# Borg Panels Timber Processing Facility Modification 4

Alterations and Additions to Site Layout  
State Significant Development Modification Assessment  
(SSD-7016-Mod-4)

May 2022

Published by the NSW Department of Planning and Environment

Figure 3 | Overview of the proposed mechanical workshop and associated hardstand area

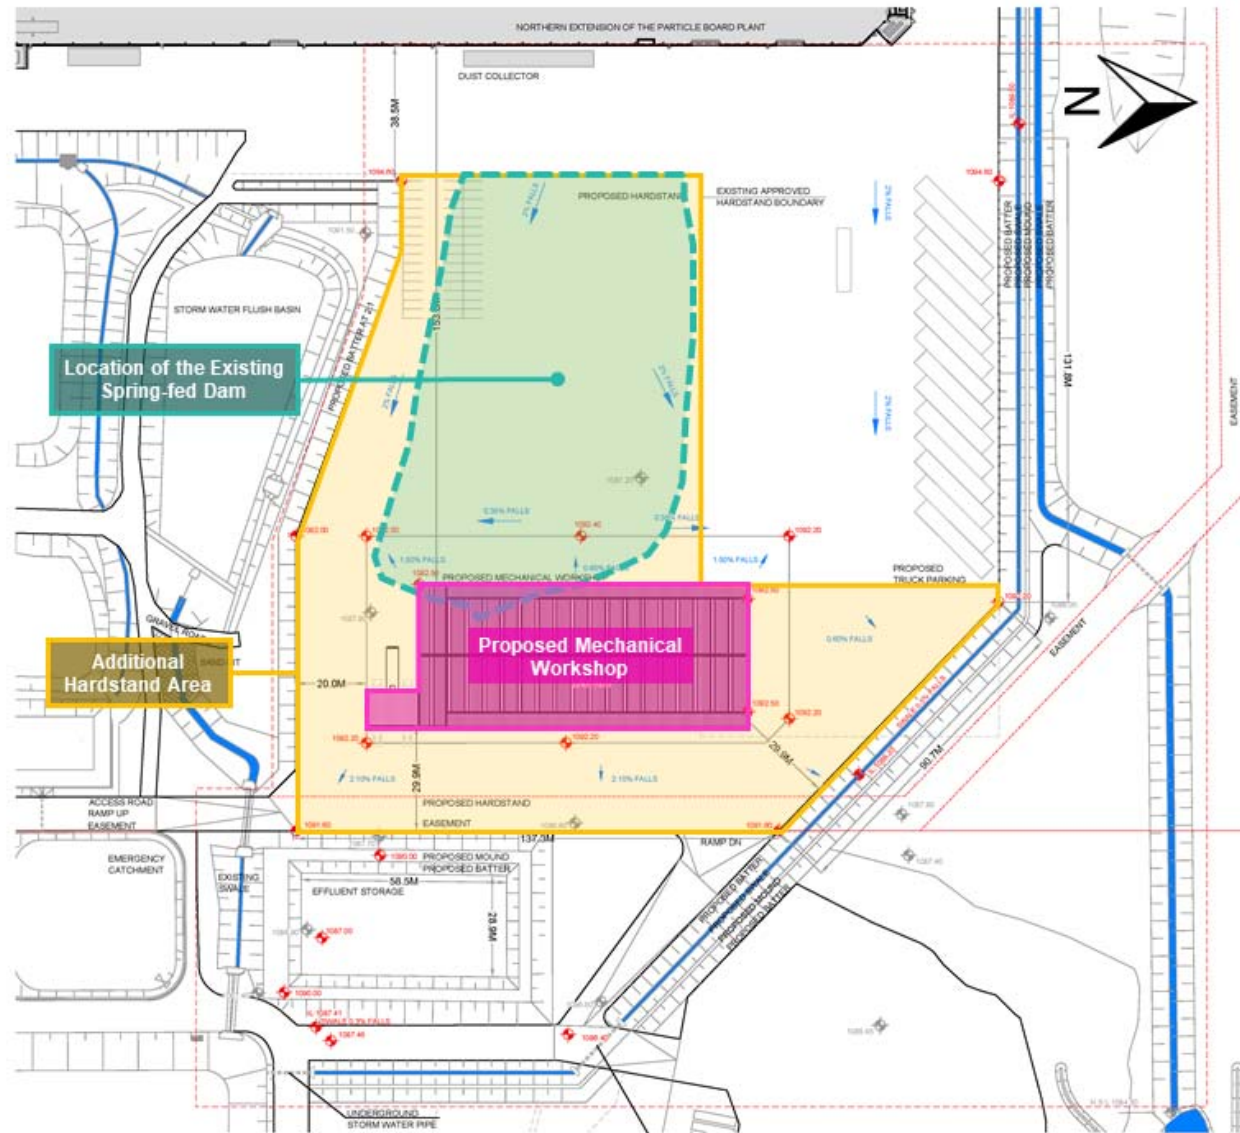
An existing spring-fed dam is located in the northern part of the site (see Figure 3). Under a previous modification (SSD-7016-Mod-1), approximately 30% of the dam was partially reclaimed, which was completed in 2020.

**Figure 4** | Overview of the proposed reclamation works

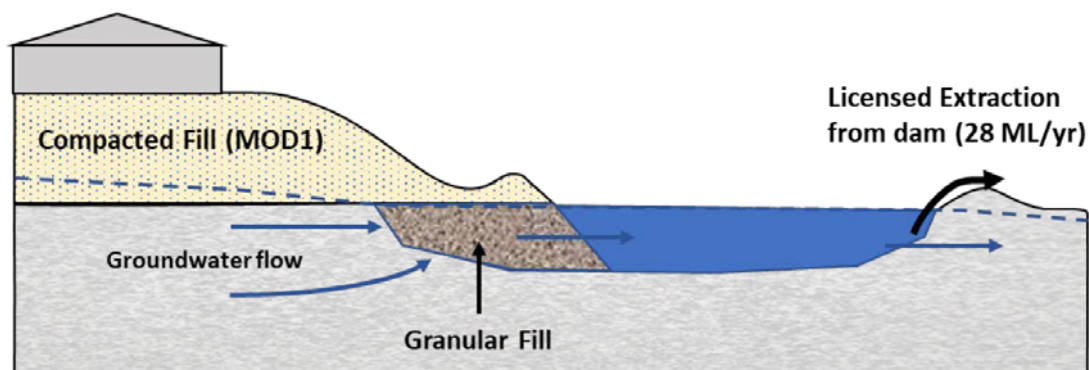
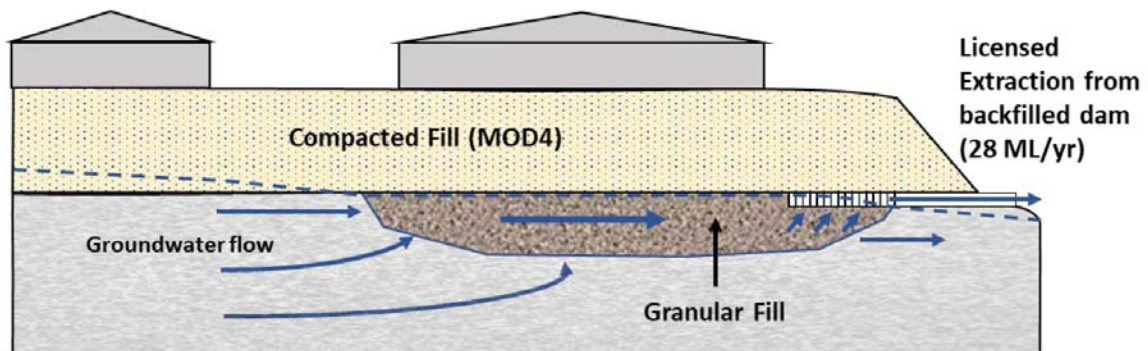
The modification would involve a full reclamation of the existing spring-fed dam to accommodate a new hardstand area and mechanic workshop. The reclamation works would rely on the same methodology used for the previous reclamation works and would involve backfilling of the dam with permeable granular material (see Figure 4) as described in **Section 2.2**. The Applicant noted the reclamation works would maintain groundwater flows, which would be achieved using groundwater harvesting methods via pits and pipes to provide a flow path for any surface water.

DPE Water and NRAR did not object to the modification but identified that the reclamation works have the potential to result in adverse groundwater impacts on downstream users and the environment. The agency required the Applicant to assess these impacts as well as provide further information on how groundwater access would be maintained. The EPA raised concerns about the potential for polluted stormwater runoff contributing to water levels in the spring-fed dam and whether material to be used for the reclamations works may be contaminated.

In its RTS, the Applicant noted groundwater inflow to the dam is in the order of 100 m<sup>3</sup>/day and through its water access licence pumps between 40 and 76 m<sup>3</sup>/day of water from the spring-fed dam for on-site use. The Applicant demonstrated the reclamation works would not result in any changes to the groundwater inflow rates as described above, but it noted that reclaiming the dam would minimise evaporation losses and rainfall inputs to the dam. While this could potentially draw more groundwater from the surrounding areas into the reclaimed area, the Applicant concluded that this would be minor and is not expected to have any impact to the closest water supply works (or users) or the maintenance of baseflow to Kings Stockyard Creek.

The Department notes these recommendations are broadly covered by existing conditions in the development consent. However, the Department has recommended the Applicant update its existing management plans including the Spring Fed Dam Reclamation Management Plan and Surface Water Management Plan to reflect the works proposed under this modification and the ongoing management of the infilled dam.

The Department has reviewed the Applicant's SEE and RTS and advice provided by the government authorities and considers the Applicant's proposed reclamation methodology is suitable for carrying out the reclamation works. The Department also considers the potential groundwater impacts to surrounding users and the environment would be minimal given groundwater inflows are unlikely to change. Additionally, any residual impacts from the reclamation works can be adequately managed by the Applicant via existing conditions of consent, including the Spring Fed Dam Reclamation Management Plan, which would be updated to incorporate the modification works. The Department also acknowledges the Applicant would be required to carry out the works in line with DPE Water and NRAR guidelines including *Guidelines for Controlled Activities on Waterfront Land*.

**Figure 5 | Schematic of new emissions point associated with the upgraded MDF Press Line**

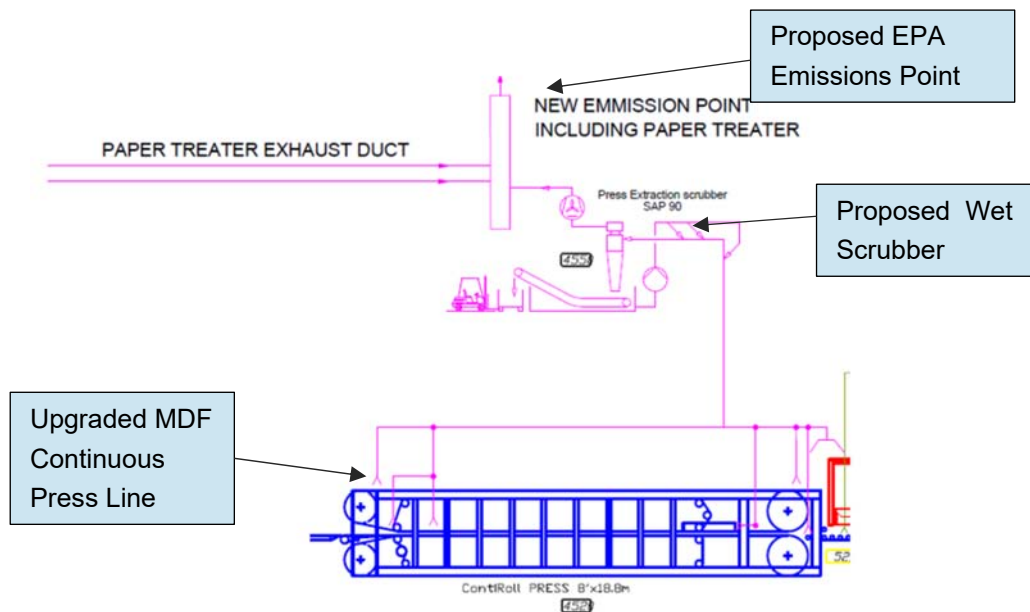
The EPA did not object to the modification but sought clarification on the emissions concentrations and parameters used in the air assessment and requested further details on the proposed scrubber that would be installed to treat formaldehyde emissions. The Applicant in its response, clarified that emission concentrations were derived from historical stack testing results and provided an emissions inventory. The Applicant also confirmed the proposed scrubber would be similar to scrubbers already in use at the site and would assist with reducing fugitive formaldehyde emissions and improving indoor air quality. The stack is proposed to be 40 m high which would enable emissions to be adequately dispersed.

While the EPA did not request any further information, it noted that air emissions from an existing paper treater at the site (which were previously diverted to a heat plant or furnace) would now be redirected to the new discharge point and would not be treated via the new scrubber (see Figure 5). The EPA recommended the Applicant undertake emissions testing of the exhaust stack to demonstrate the new plant's emission performance prior to being combined with other emissions. The Department notes that such testing requirements would be captured under the Applicant's EPL and is broadly covered under a standard condition in the consent, which requires the Applicant to comply with air quality monitoring requirements as specified in the EPL. The Department considers no new conditions are required, however has recommended the existing Air Quality Management Plan (AQMP) for the site be updated to incorporate the modification.

The Department is of the view the modification would not lead to additional air quality impacts beyond the site boundary and is satisfied the Applicant would continue to work closely with the EPA to improve air quality across the site. The Department notes that existing conditions are in place, such as the AQMP to ensure the Applicant continues to manage air quality emissions from the site in line with the
